CHANGE ORDER FORM

CHANGE ORDER NUMBER 15

PROJECT: FM 1093 WESTPARK EXTENSION: CONSTRUCTION CONSISTING OF GRADING, LIME TREATED SUBGRADE, PORTLAND CEMENT TREATED BASE, CONCRETE PAVEMENT, STORM SEWERS, STRUCTURES, RETAINING WALLS, ETC.

RE: FM 1093 Westpark Extension  
Limits: From FM 1463/359 to West of Katy-Gaston Road and from West of Katy-Gaston Road to West of SH 99  
For Construction Consisting Of Grading, Lime Treated Subgrade, Portland Cement Treated Base, Concrete Pavement, Storm Sewers, Structures, Retaining Walls, Etc.  
**CHANGE ORDER 15 JUSTIFICATION**

det basin 03 surface report  
SURFACE TO SURFACE VOLUME REPORT

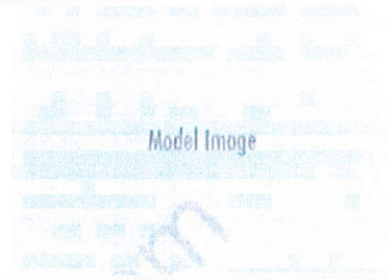
Per the attached survey data, basin 2 had a grade bust from the plan quantities of 2,065.4CY of unsuitable (super saturated) material which had to be excavated to achieve grade. An additional 2-3 feet was over-excavated to reach suitable subgrade and embankment was imported to achieve final grade which is quantified at 2,003 CY. Basin 3 required an additional 4-5 feet of over excavation to remove the unsuitable material to allow for embankment of suitable material.
